DRAINAGE LETTER

LOT 11, ROLLING THUNDER BUSINESS PARK

Revised
September 24, 2021

County File No.: PPR-21-24

DRAINAGE PLAN HISTORIC CONDITIONS

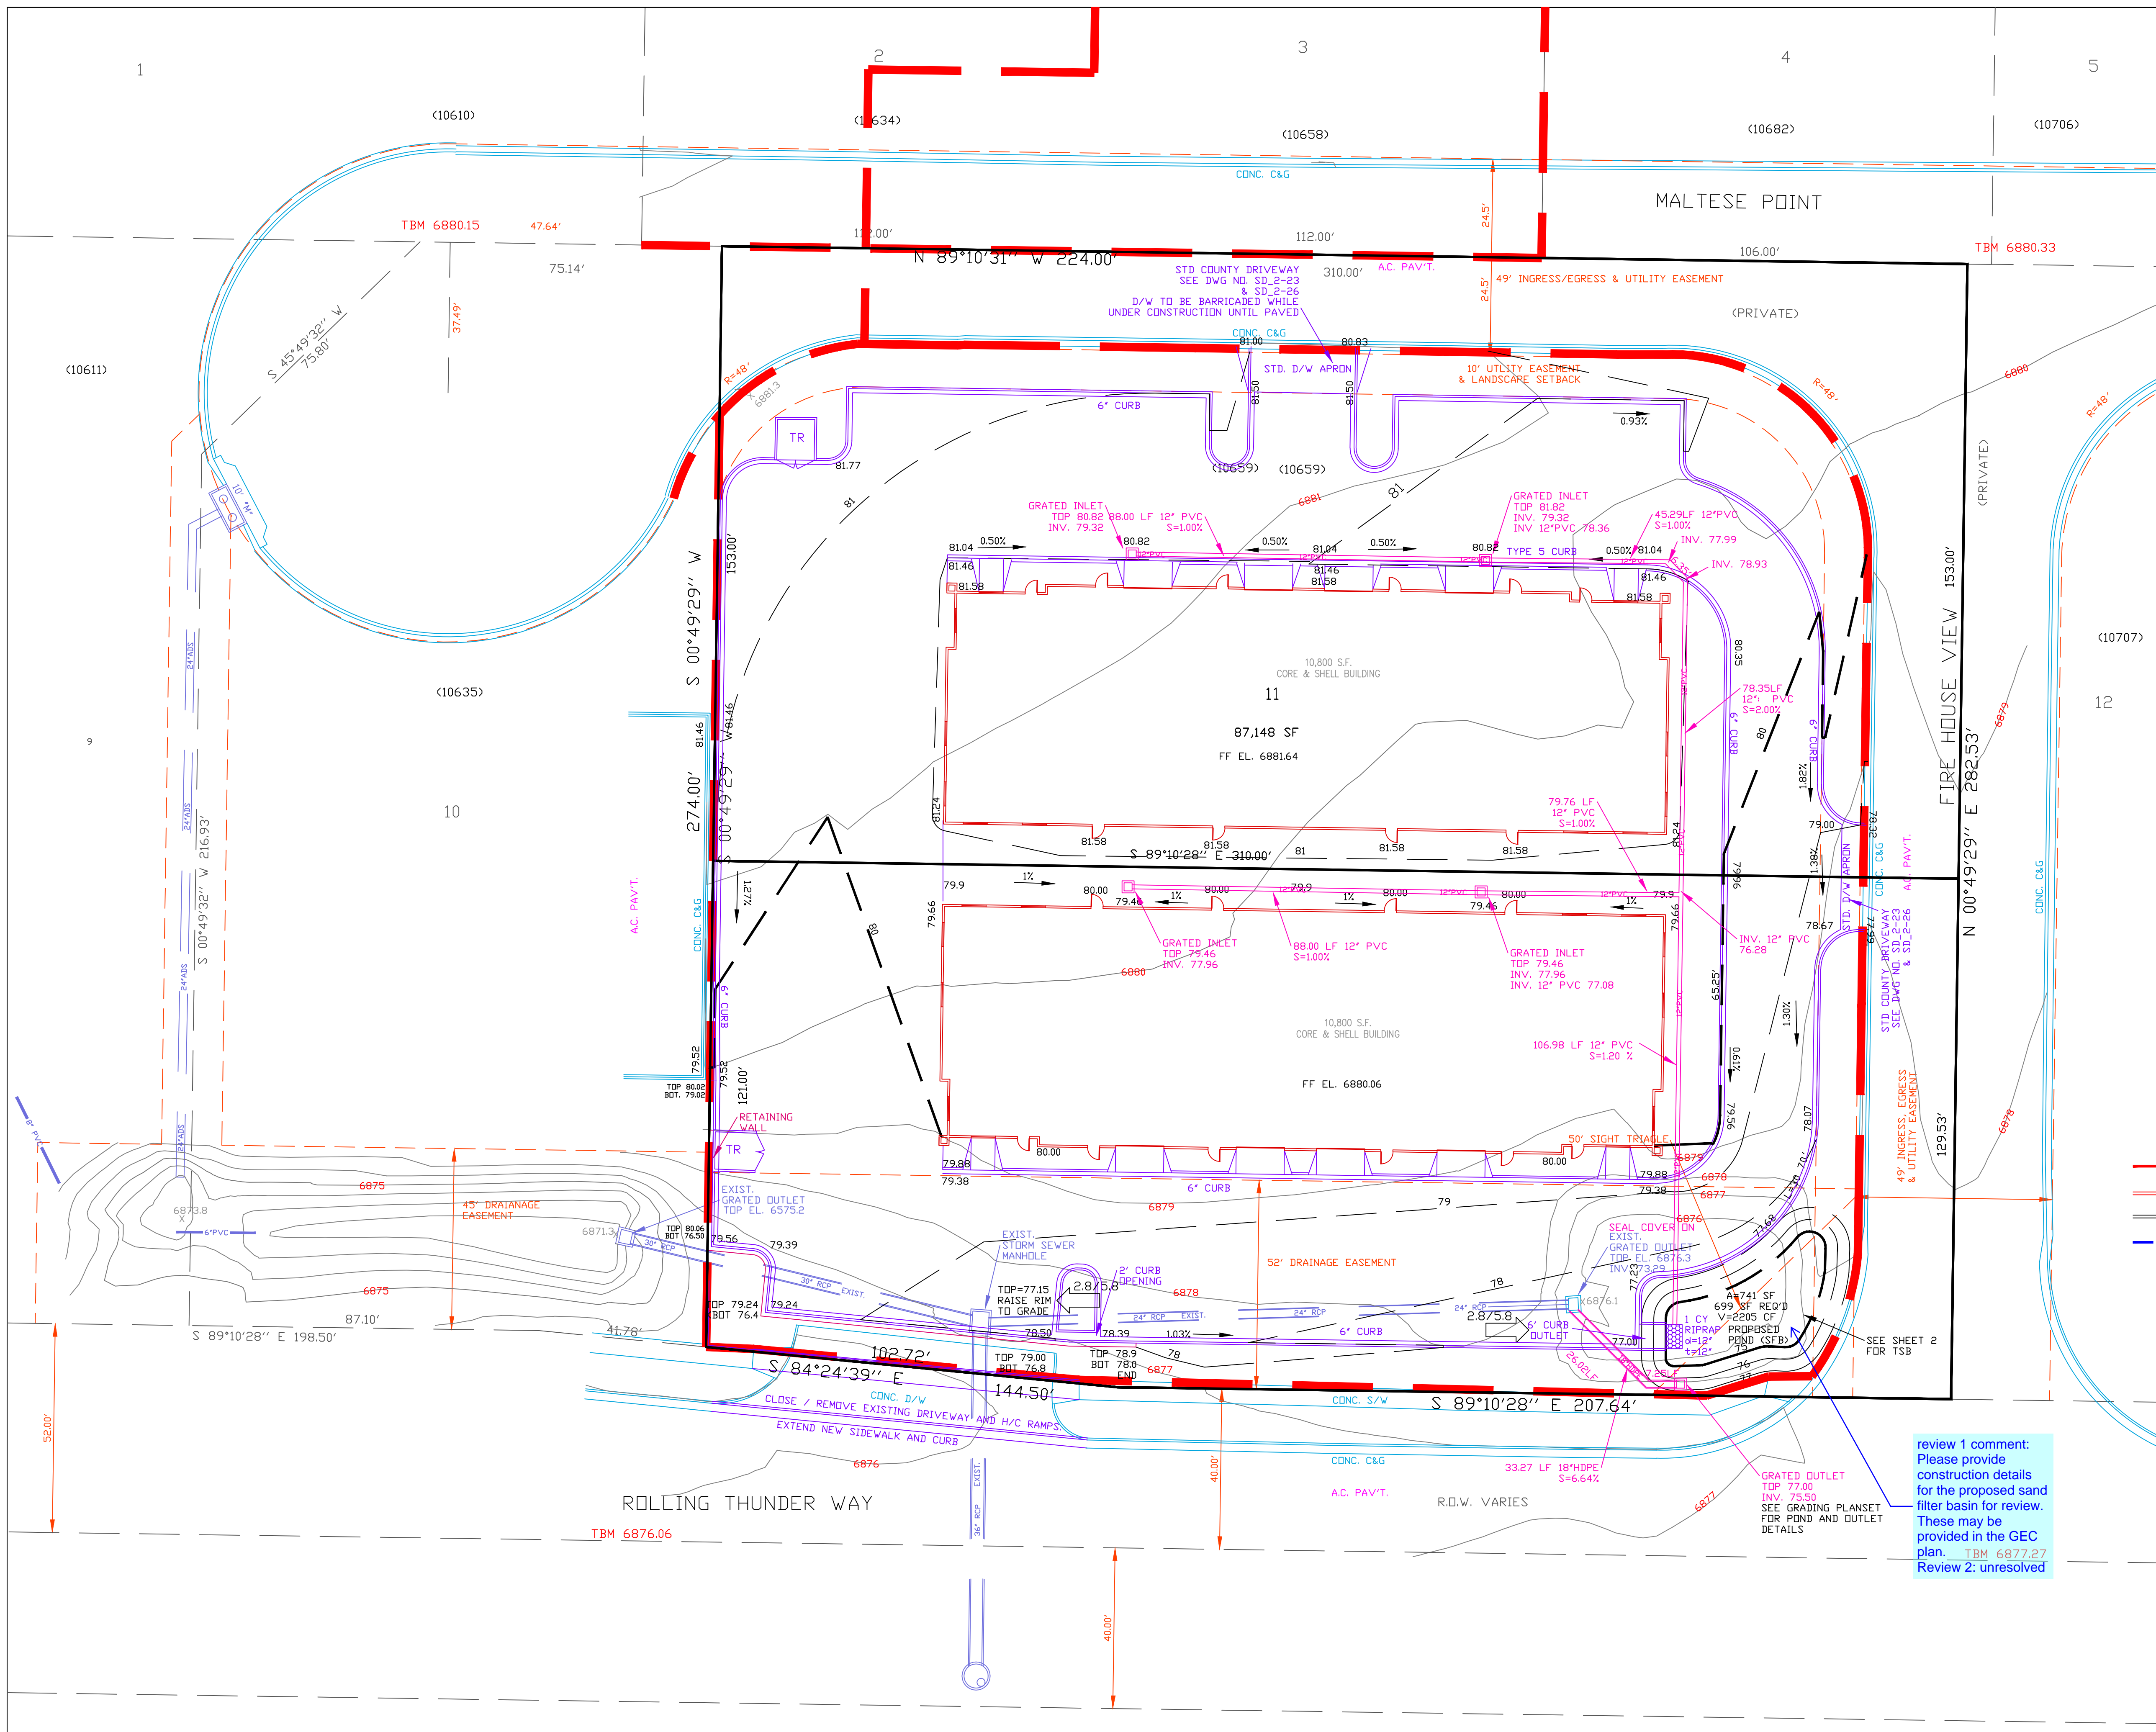
review 1 comment:
Please provide construction details for the proposed sand filter basin for review. These may be provided in the GEC plan. TBM 6877.27
Review 2: unresolved
